April 24, 2017

To the Members of the Manhattan Beach City Council:

Attachment: **Peer Review Traffic, Circulation and Parking Issues – Proposed Gelsons Shopping Center at 707 and 801 N. Sepulveda Boulevard in Manhattan Beach, California, by Allyn D. Rifkin, dated August 19, 2016. -- submitted as part of the public comments on the Gelson's project.**

Peer Review Traffic, Circulation and Parking Issues – Proposed Gelsons Shopping Center at 707 and 801 N. Sepulveda Boulevard in Manhattan Beach, California

EXHIBIT 4 – Gelsons 8TH STREET DRIVEWAY and the Existing SEPULVEDA LEFT TURN LANE

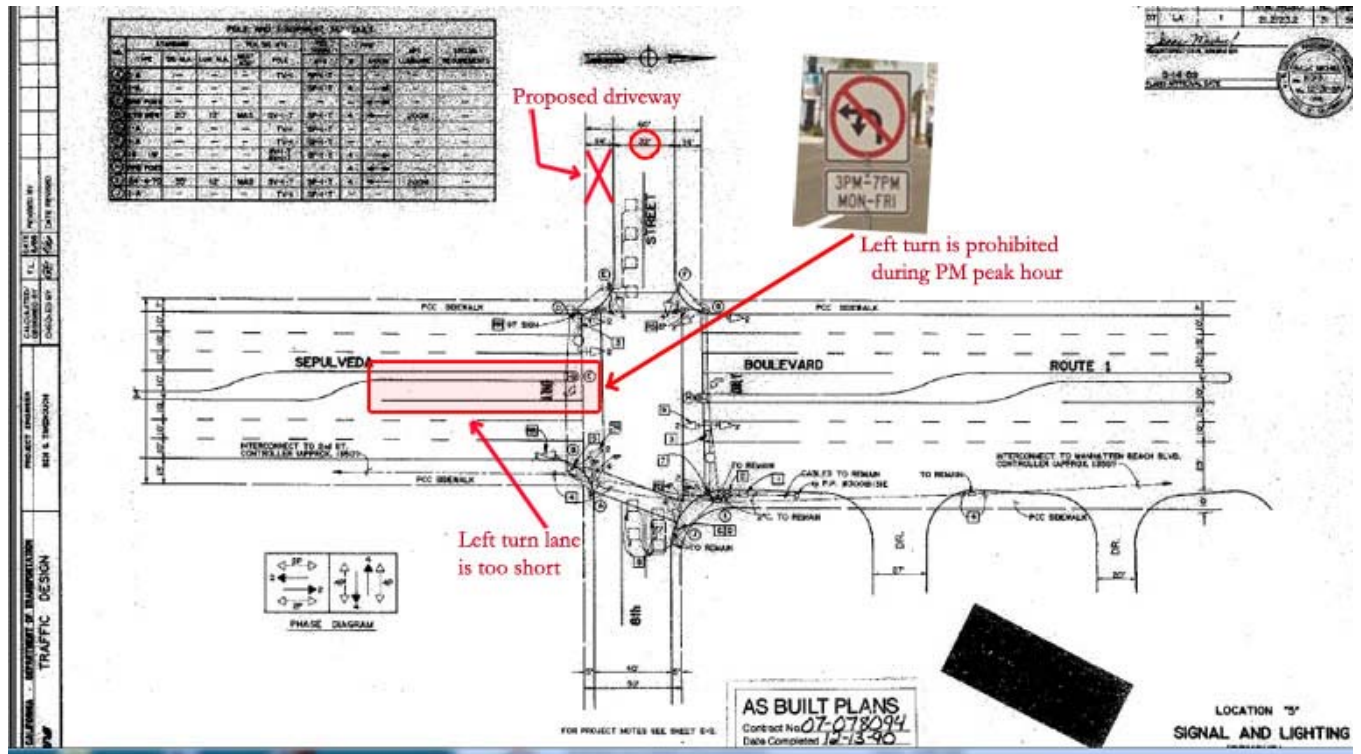
4. Virtually all of the traffic from the south must make a left turn in the north bound left turn lane at Sepulveda Boulevard and 8th Street. This represents 38 percent of all inbound trips, or 61 vehicles per hour in the PM peak hour (per Figure 8 of the traffic study). This does not include expected truck deliveries which also may be included during the peak hour. Unfortunately there

EXHIBIT 4 shows the existing layout of the Sepulveda/8th Street intersection. Currently, northbound left turns are prohibited during the PM peak hour. According to the Traffic Study (see Figure 5) 6 vehicles per hour are currently using this northbound left turn lane (apparently illegally) during the PM peak hour. The Traffic Study assumes that the City would install left turn arrow to replace the left turn restriction by the time the project is constructed. This is unsubstantiated as this improvement depends upon funding from the Los Angeles County Metropolitan Transit Authority (METRO) which had recently delayed the improvement. **The traffic analysis must re-evaluate this intersection with and without the left turn arrow to determine if there may be a significant impact leading to a developer responsibility to install the left turn arrow.**

EXHIBIT 10

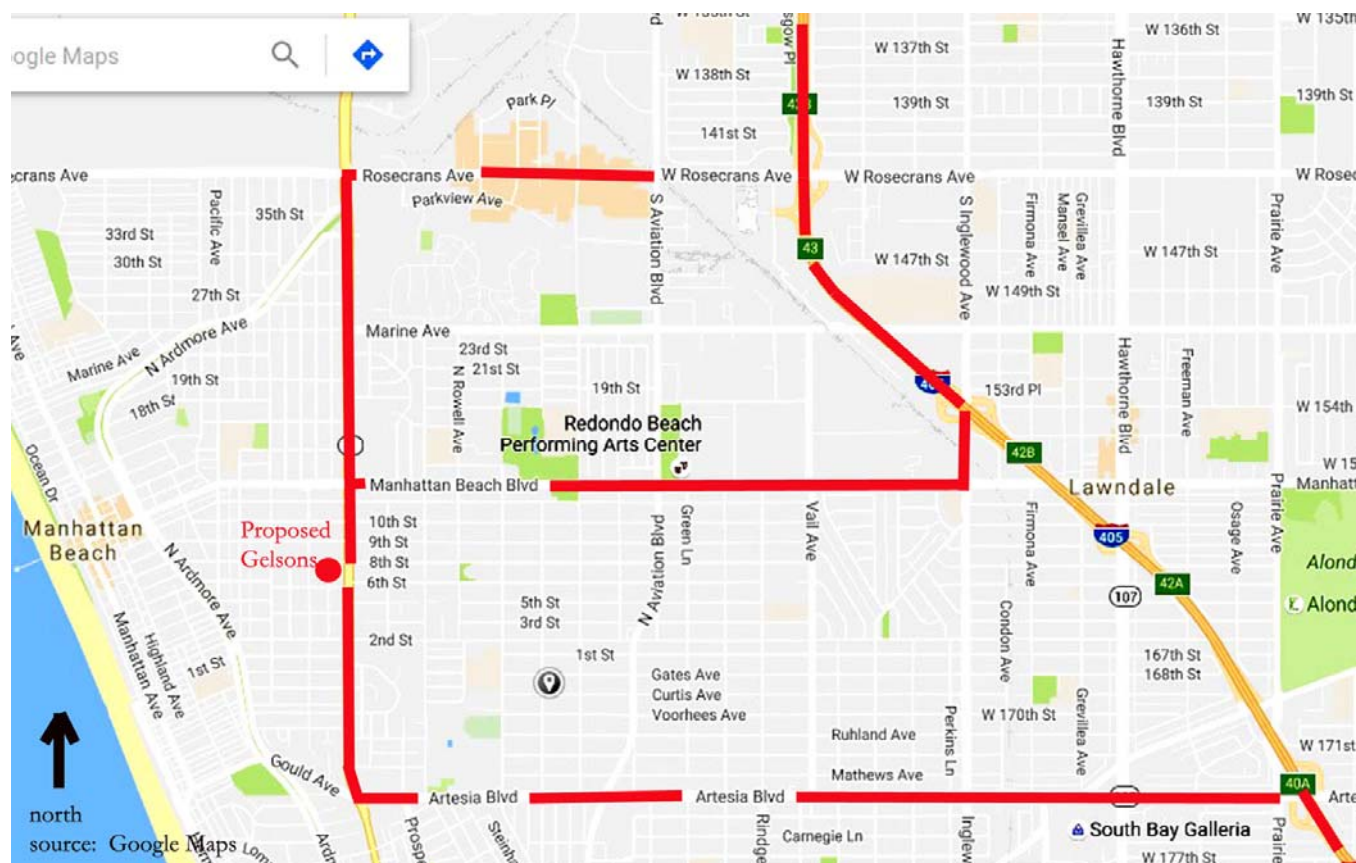
The proposed site plan would widen 8th Street by 3 feet to provide an additional east bound lane at Sepulveda Boulevard (see EXHIBIT 10). Single trailer trucks cannot negotiate egress from the driveway without crossing over into the on-coming traffic. EXHIBIT 11 is diagram of the existing roadway design with a prototypical truck movement turning southbound from Sepulveda Boulevard to 8th Street. To make that turn, trucks would have to encroach 28 feet from the north curb of 8th Street. The proposed site plan center line for the new left turn lane accommodates only 13 feet for that movement. **The project should be required to further widen the south side of 8th Street to better accommodate the truck access.**

7. The site plan shows a minor widening of the roadway to create a right turn lane into the project (again see EXHIBIT 10). This "turn-out" is shown as 78 feet, including the 40 foot transition. This is sufficient to accommodate only 2 vehicles in a queue going into the parking lot. While there are no apparent standards for commercial driveway turn-out lanes an inventory of existing turn-out lanes recently constructed on Sepulveda Boulevard in the vicinity of this project reveals that only one installation (the driveway for the Panda Express, a few blocks to the south) is as short as proposed for this project (see EXHIBIT 12). **The "turn-out" for this project should be longer to accommodate a larger number of vehicles.**

PARAGON FURTHER GAMED PARKING BY ANALYZING 28 SEATS VS 32 SEATS ON PLAN BELOW

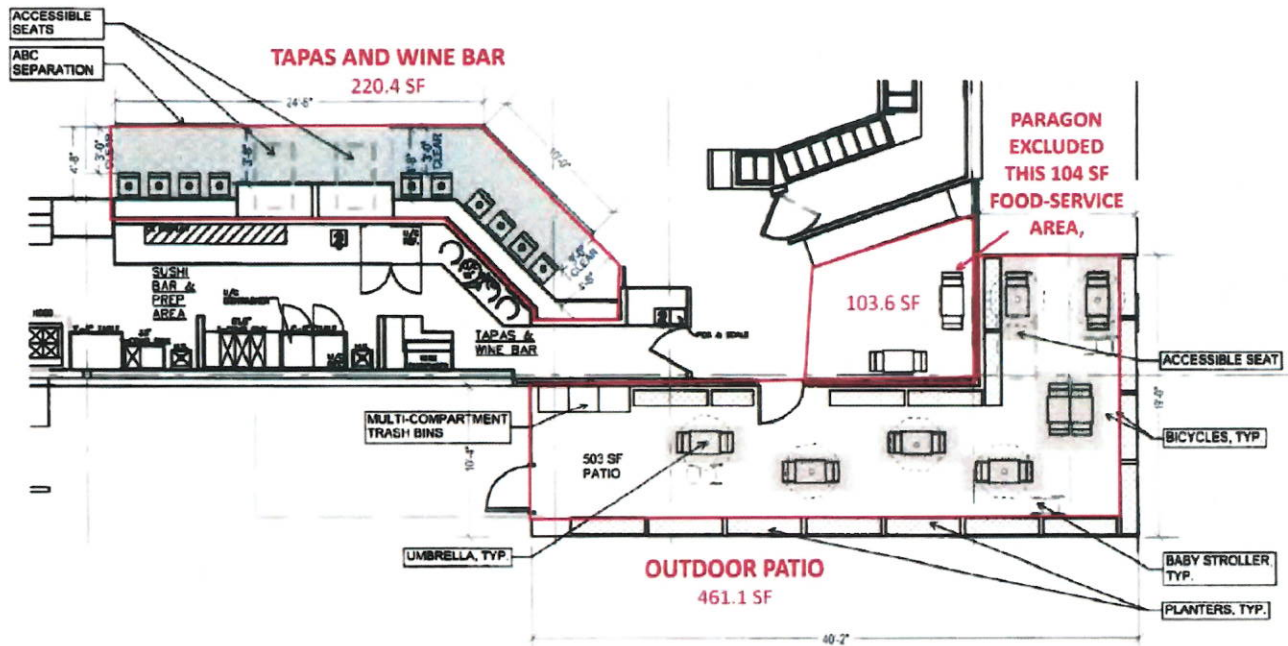
TABLE-CHAIR SEATING AREA 31 SF PER SEAT, TWICE THE HOLLYWOOD STORE 15 SF!

NET INDOOR-OUTDOOR EATING & DRINKING AREA, 785 SF,
16 PARKING SPACES @ 1 PER 50 SF FOR SIT-DOWN VS PARAGON'S 10 SPACES
[Pg. 222, 8 Feb 2017 Staff Report and MBMC 10.64.030]

PARAGON GAMED FOOD-SERVICE PARKING BY REDUCING NUMBER OF SEATS

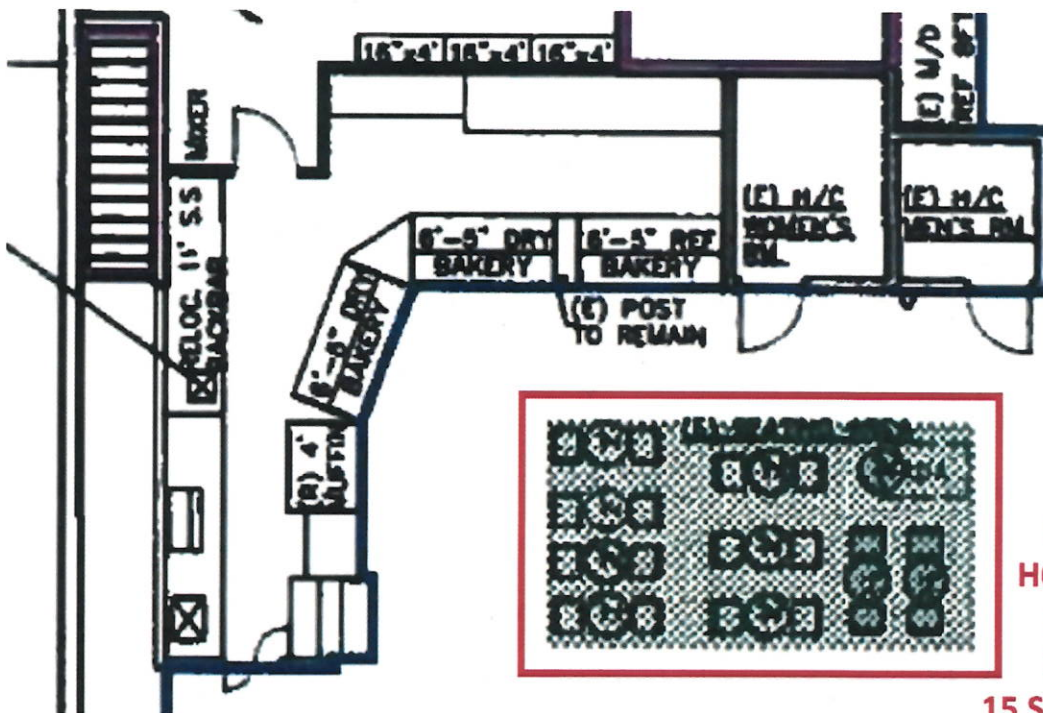
- GELSON'S HOLLYWOOD STORE SEATING DENSITY: 15 SQ-FT PER SEAT. [See below]
- GELSON'S MANHATTAN STORE SEATING DENSITY: **31 SQ-FT PER SEAT**. [See next slide]
- STATE BUILDING CODE REQUIRES 15 SQ-FT MINIMUMS PER SEAT [Title 24, Part 2, Chapter 10, Table 1004.1.1]

NOTE: PARAGON CALCULATES PARKING **PER SEAT**. THE APPROVED USE PERMIT SPECIFIES PARKING BY AREA.
GELSON'S WILL PACK THE FOOD AREA WITH CHAIRS, ADDING 8 MORE SPACES TO PARKING DEMAND.
